| Project | ADELAIDE CENTRAL PLA |
| SKS No. | J1301-STR-SKT-0001 |
| Sketch | STRUCTURAL CONCEPT SKETCHES |

| Project | Drawing | Date | Issue |
|---|---|---|---|
| Adelaide Central Plaza Tower - Premium A-Grade Commercial | 24176 - DR-02-01 | 14.03.25 | Prelim - Issue 05 - For Co-ordination |

BASEMENT - PLAN
FLOOR PLAN scale1 : 250

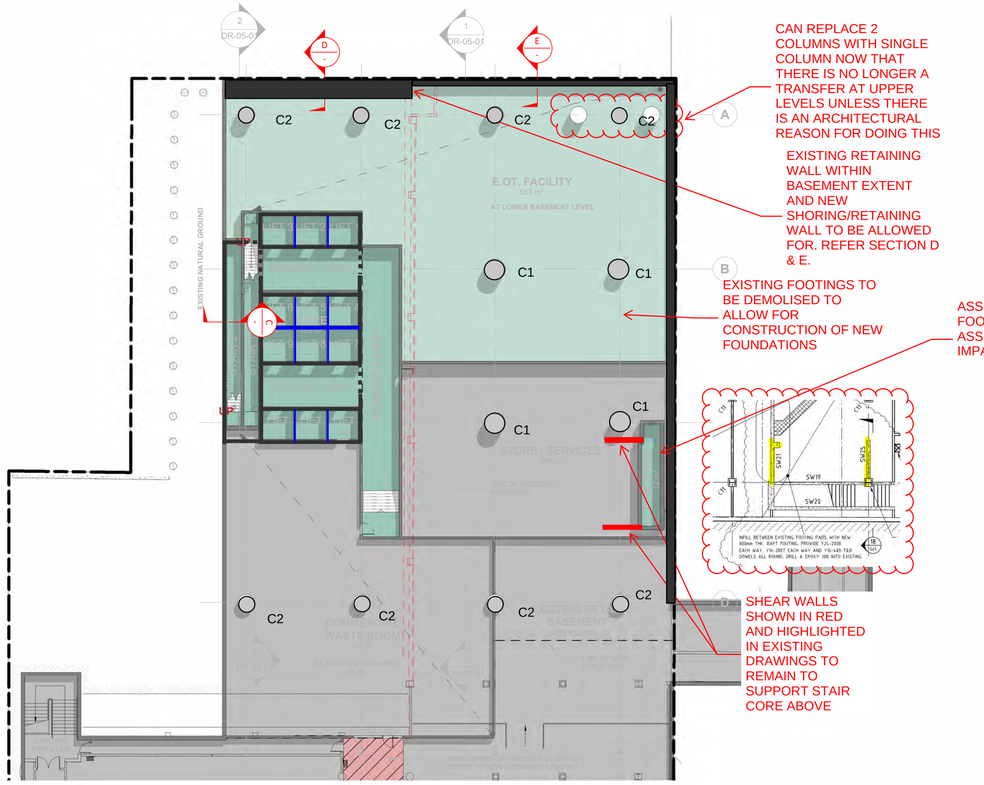
CAN REPLACE 2 COLUMNS WITH SINGLE COLUMN NOW THAT THERE IS NO LONGER A TRANSFER AT UPPER LEVELS UNLESS THERE IS AN ARCHITECTURAL REASON FOR DOING THIS

EXISTING RETAINING WALL WITHIN BASEMENT EXTENT AND NEW SHORING/RETAINING WALL TO BE ALLOWED FOR. REFER SECTION D & E.

EXISTING FOOTINGS TO BE DEMOLISED TO ALLOW FOR CONSTRUCTION OF NEW FOUNDATIONS

ASSESSMENT OF STAIR FOOTING REQUIRED TO ASSESS FURTHER IMPACTS OF

SHEAR WALLS SHOWN IN RED AND HIGHLIGHTED IN EXISTING DRAWINGS TO REMAIN TO SUPPORT STAIR CORE ABOVE

GROUND - LOWER - PLAN
FLOOR PLAN scale1 : 250

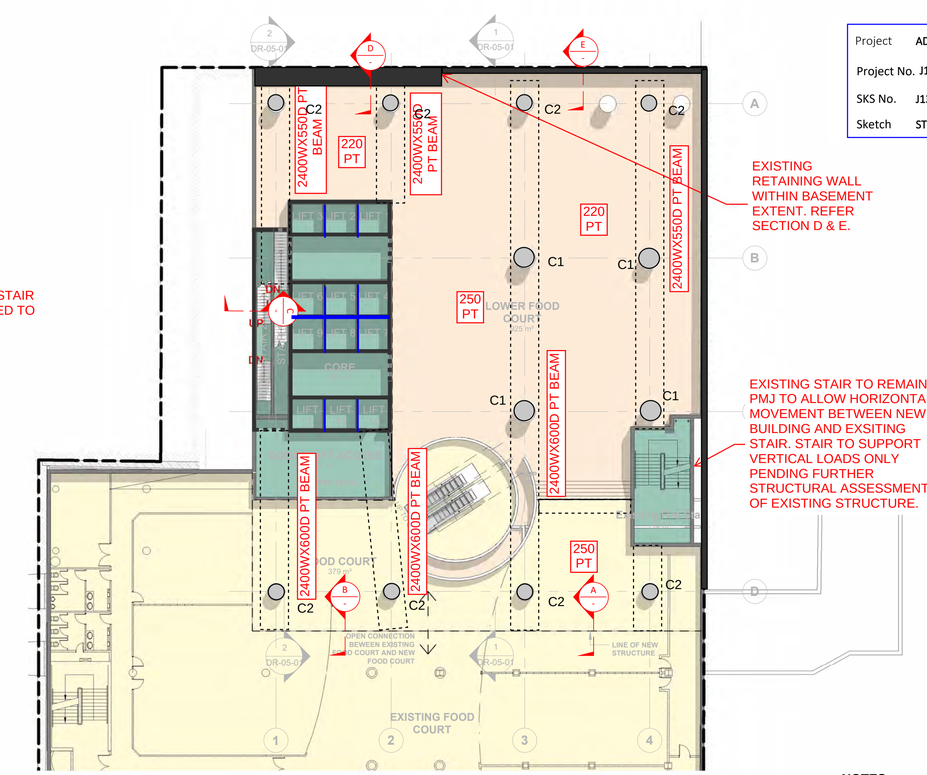
EXISTING RETAINING WALL WITHIN BASEMENT EXTENT. REFER SECTION D & E.

EXISTING STAIR TO REMAIN. PMJ TO ALLOW HORIZONTAL MOVEMENT BETWEEN NEW BUILDING AND EXSITING STAIR. STAIR TO SUPPORT VERTICAL LOADS ONLY PENDING FURTHER STRUCTURAL ASSESSMENT OF EXISTING STRUCTURE.

GROUND - PLAN
FLOOR PLAN scale1 : 250

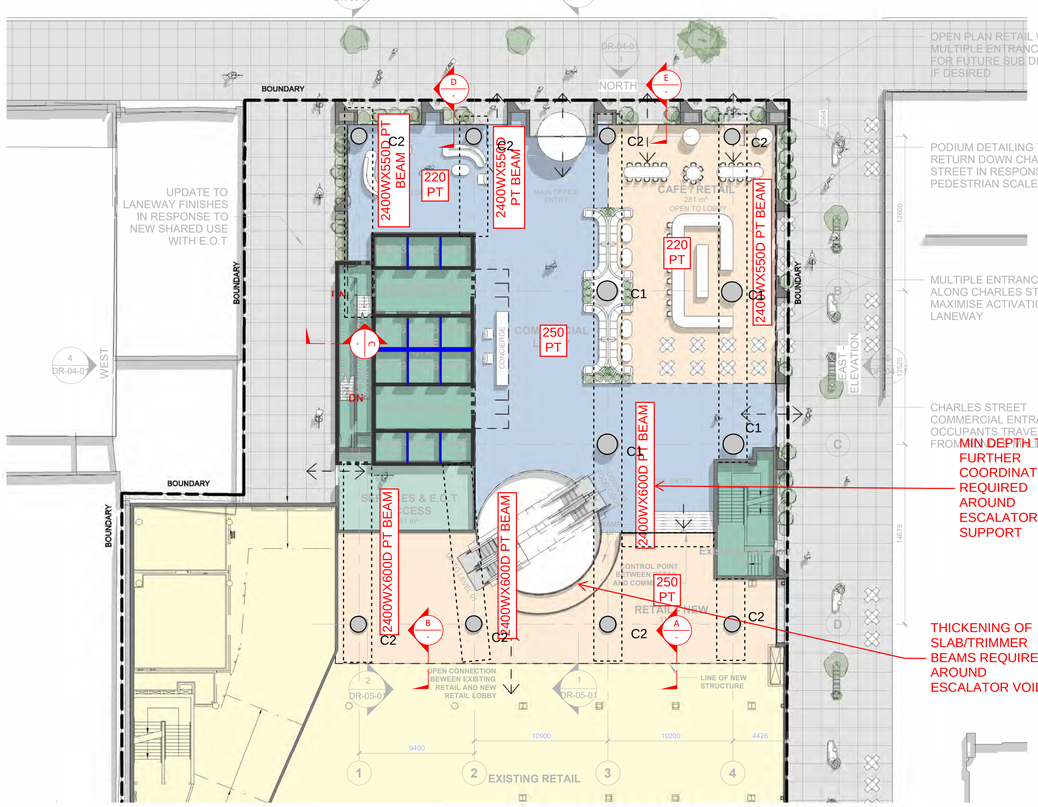
MIN DEPTH TYP. FURTHER COORDINATION REQUIRED AROUND ESCALATOR SUPPORT

THICKENING OF SLAB/TRIMMER BEAMS REQUIRED AROUND ESCALATOR VOID

LEVEL 1 - PLAN
FLOOR PLAN scale1 : 250

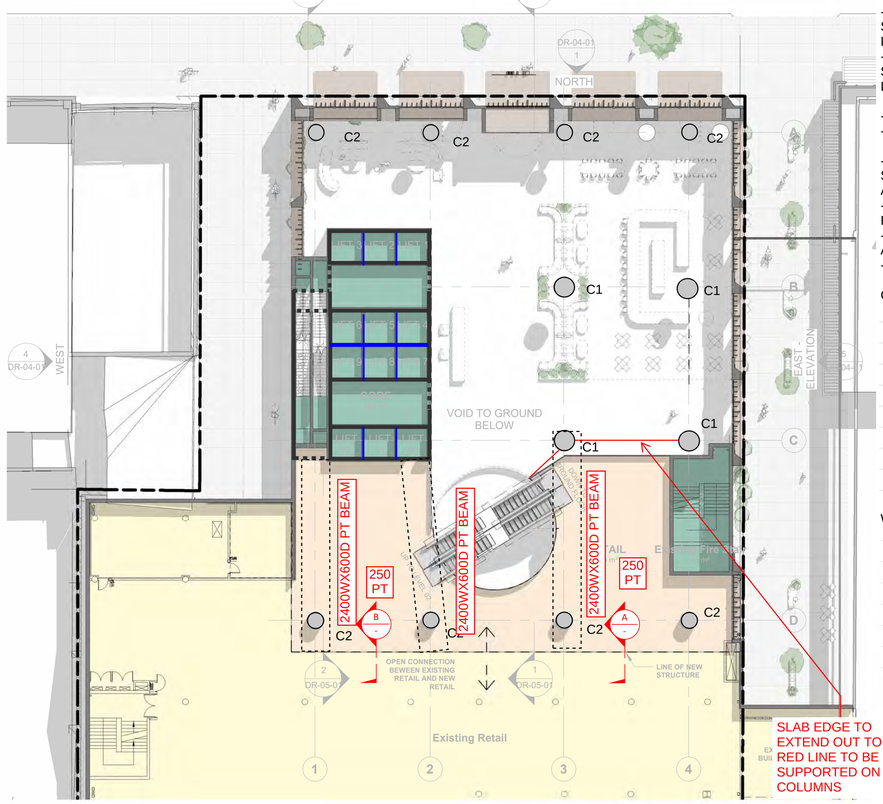
SLAB EDGE TO EXTEND OUT TO RED LINE TO BE SUPPORTED ON COLUMNS

LEVEL 2 - PLAN
FLOOR PLAN scale1 : 250

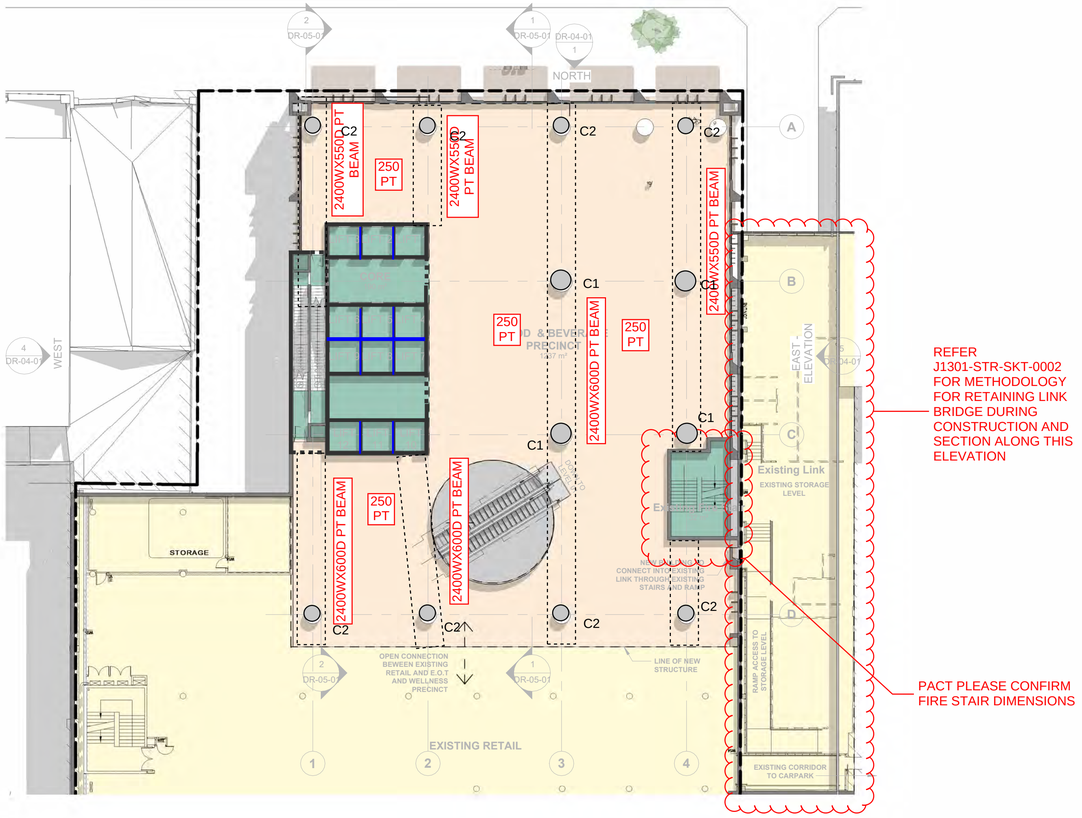
REFER J1301-STR-SKT-0002 FOR METHODOLOGY FOR RETAINING LINK BRIDGE DURING CONSTRUCTION AND SECTION ALONG THIS ELEVATION

PACT PLEASE CONFIRM FIRE STAIR DIMENSIONS

LEVEL 3 - PLAN
FLOOR PLAN scale1 : 250

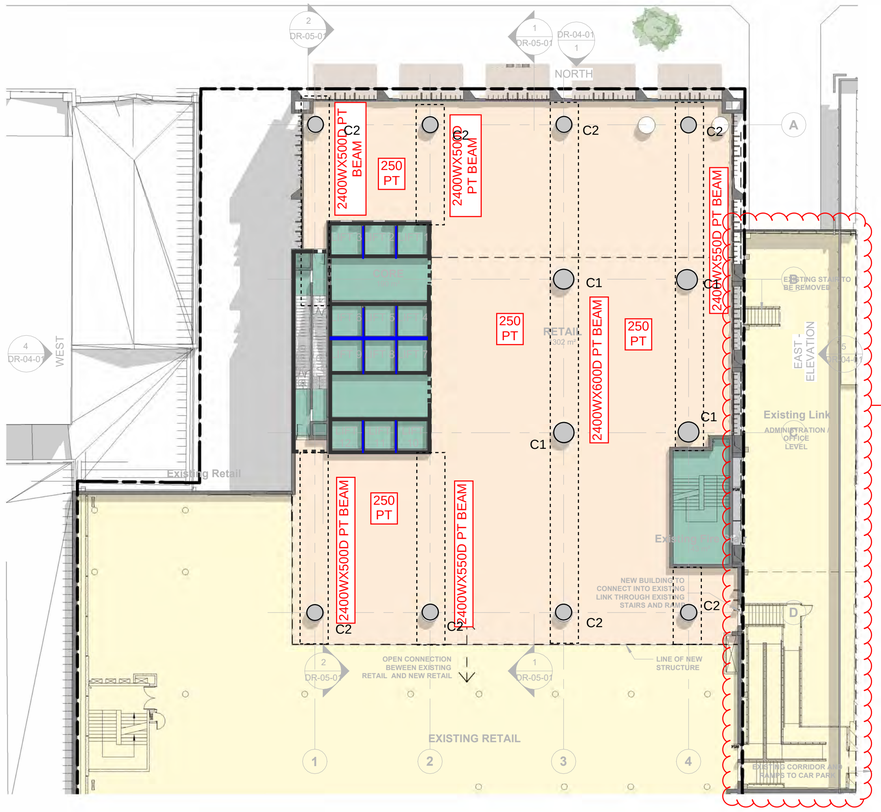
REFER J1301-STR-SKT-0002 FOR METHODOLOGY FOR RETAINING LINK BRIDGE DURING CONSTRUCTION AND SECTION ALONG THIS ELEVATION

LEVEL 4 - PLAN
FLOOR PLAN scale1 : 250

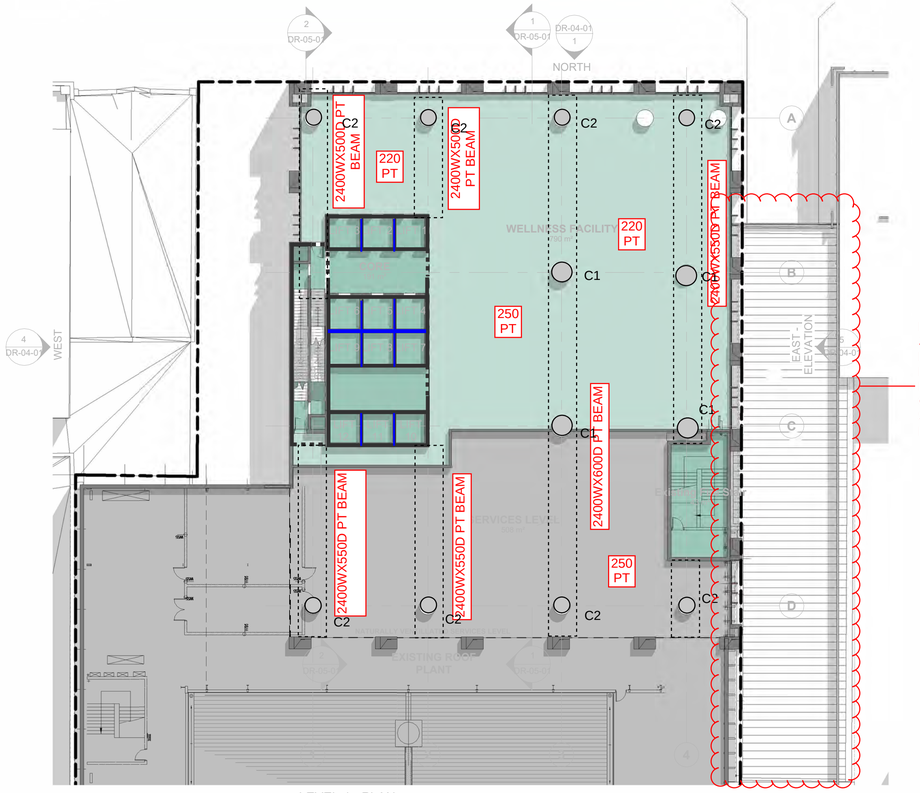
REFER J1301-STR-SKT-0002 FOR METHODOLOGY FOR RETAINING LINK BRIDGE DURING CONSTRUCTION AND SECTION ALONG THIS ELEVATION

LOWER COMMERCIAL LEVELS 05 - PLAN
FLOOR PLAN scale1 : 250

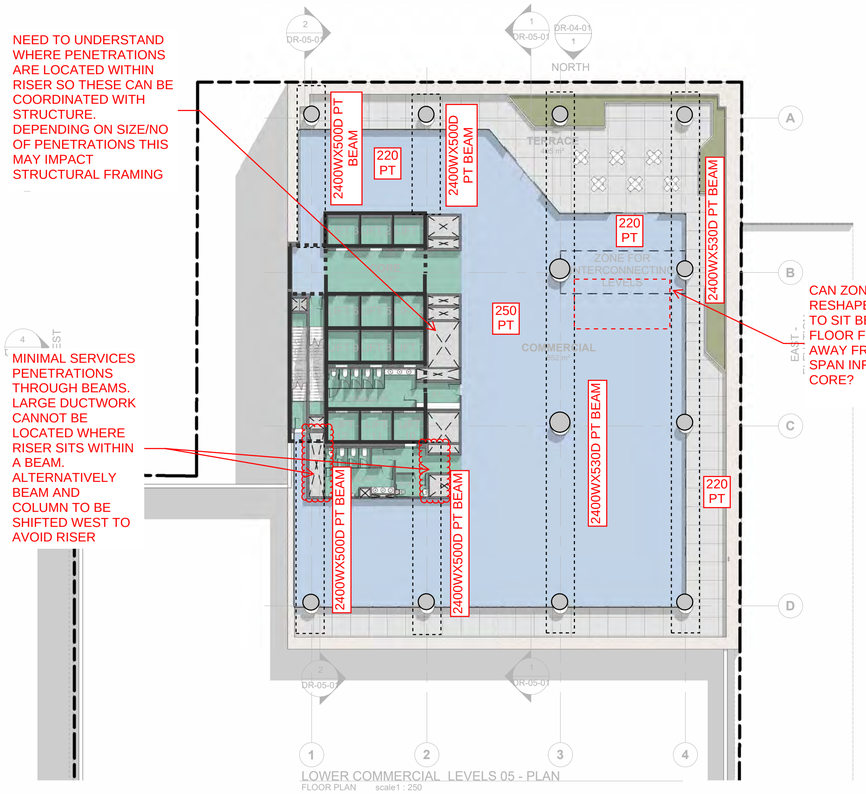
NEED TO UNDERSTAND WHERE PENETRATIONS ARE LOCATED WITHIN RISER SO THESE CAN BE COORDINATED WITH STRUCTURE. DEPENDING ON SIZE/NO OF PENETRATIONS THIS MAY IMPACT STRUCTURAL FRAMING

MINIMAL SERVICES PENETRATIONS THROUGH BEAMS. LARGE DUCTWORK CANNOT BE LOCATED WHERE RISER SITS WITHIN A BEAM. ALTERNATIVELY BEAM AND COLUMN TO BE SHIFTED WEST TO AVOID RISER

CAN ZONE BE RESHAPED/ROTATED TO SIT BETWEEN FLOOR FRAMING AND AWAY FROM SINGLE SPAN INFRONT OF CORE?

LEVEL 6 - PLAN
FLOOR PLAN scale1 : 250

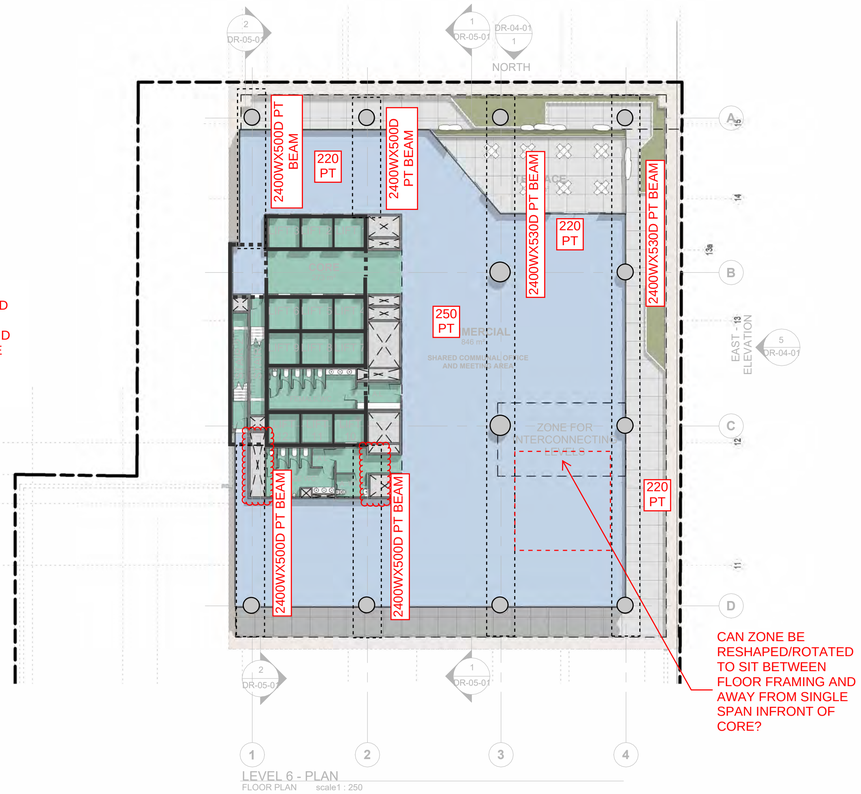
CAN ZONE BE RESHAPED/ROTATED TO SIT BETWEEN FLOOR FRAMING AND AWAY FROM SINGLE SPAN INFRONT OF CORE?

300WX800D BEAM TO CANTILEVER OFF CORE WALL (TYP LOW RISE COMMERCIAL LEVELS)

COMMERCIAL LEVEL 07 - 17 - PLAN
FLOOR PLAN scale1 : 250

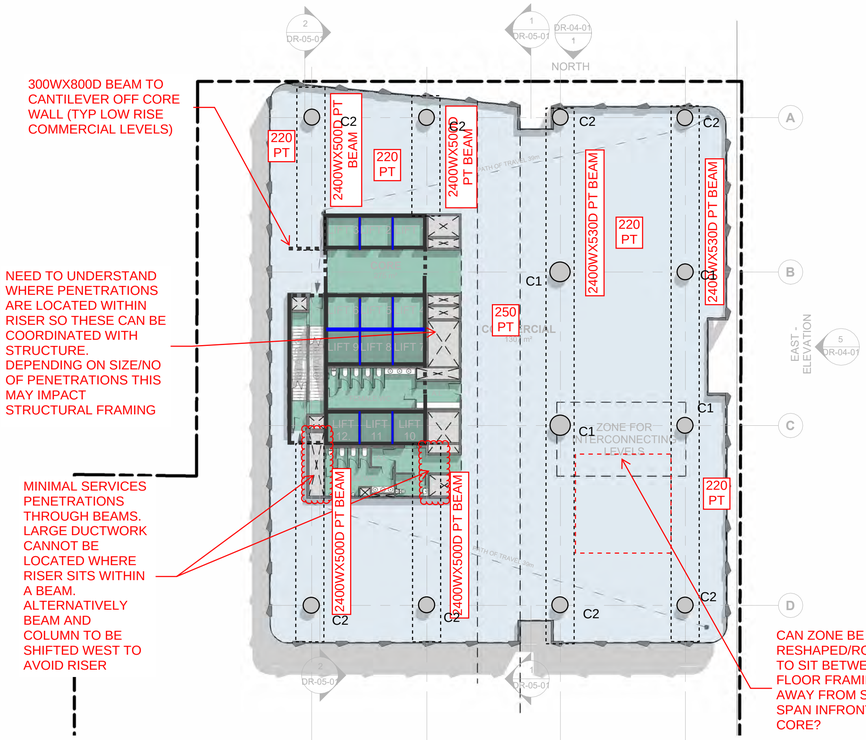
NEED TO UNDERSTAND WHERE PENETRATIONS ARE LOCATED WITHIN RISER SO THESE CAN BE COORDINATED WITH STRUCTURE. DEPENDING ON SIZE/NO OF PENETRATIONS THIS MAY IMPACT STRUCTURAL FRAMING

MINIMAL SERVICES PENETRATIONS THROUGH BEAMS. LARGE DUCTWORK CANNOT BE LOCATED WHERE RISER SITS WITHIN A BEAM. ALTERNATIVELY BEAM AND COLUMN TO BE SHIFTED WEST TO AVOID RISER

CAN ZONE BE RESHAPED/ROTATED TO SIT BETWEEN FLOOR FRAMING AND AWAY FROM SINGLE SPAN INFRONT OF CORE?

COMMERCIAL LEVEL 18 - 30 - PLAN
FLOOR PLAN scale1 : 250

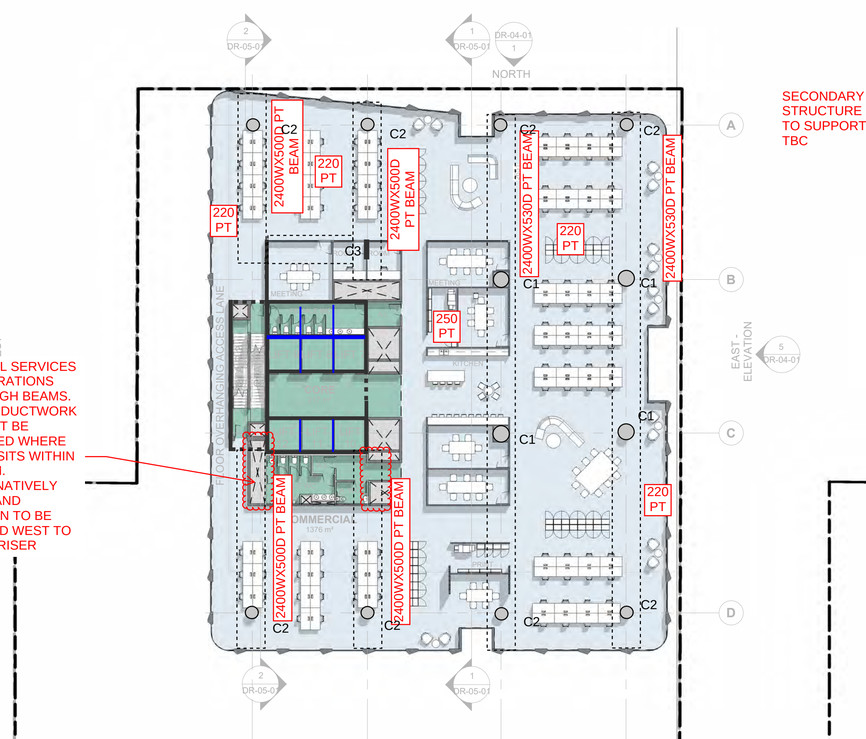
MINIMAL SERVICES PENETRATIONS THROUGH BEAMS. LARGE DUCTWORK CANNOT BE LOCATED WHERE RISER SITS WITHIN A BEAM. ALTERNATIVELY BEAM AND COLUMN TO BE SHIFTED WEST TO AVOID RISER

ROOF PLAN

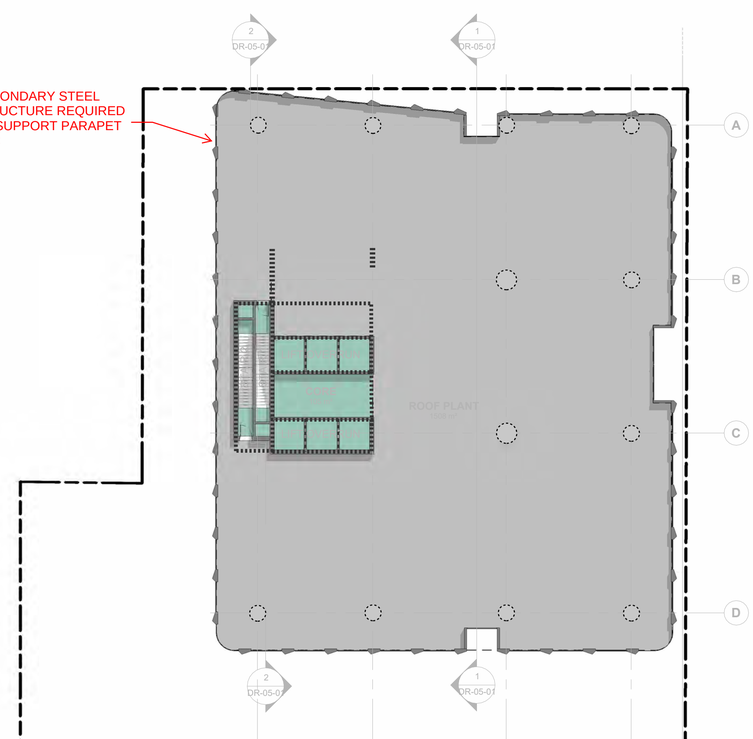
SECONDARY STEEL STRUCTURE REQUIRED TO SUPPORT PARAPET TBC

GROUND - EXISTING & DEMO
FLOOR PLAN scale1 : 400

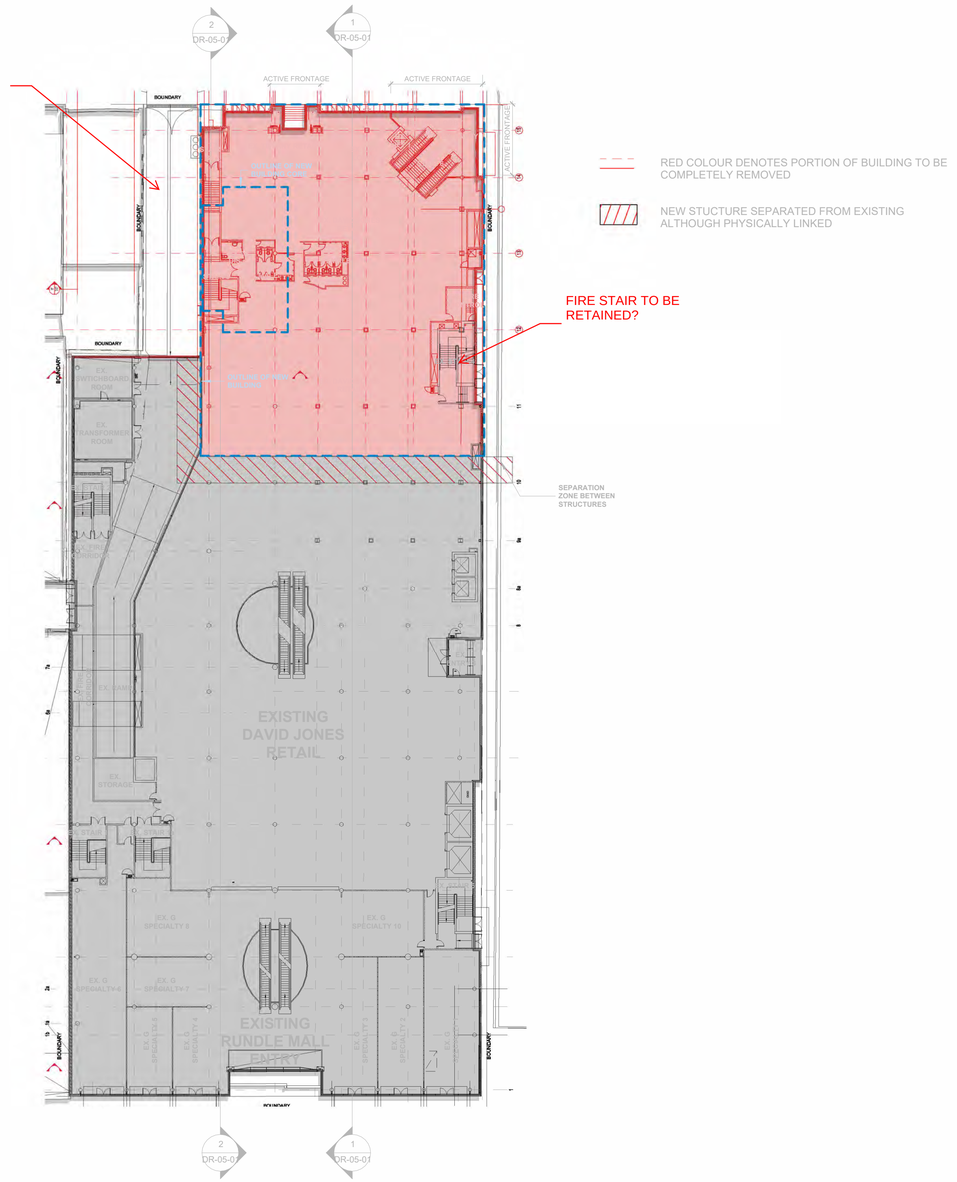
RED COLOUR DENOTES PORTION OF BUILDING TO BE COMPLETELY REMOVED

NEW STUCTURE SEPARATED FROM EXISTING ALTHOUGH PHYSICALLY LINKED
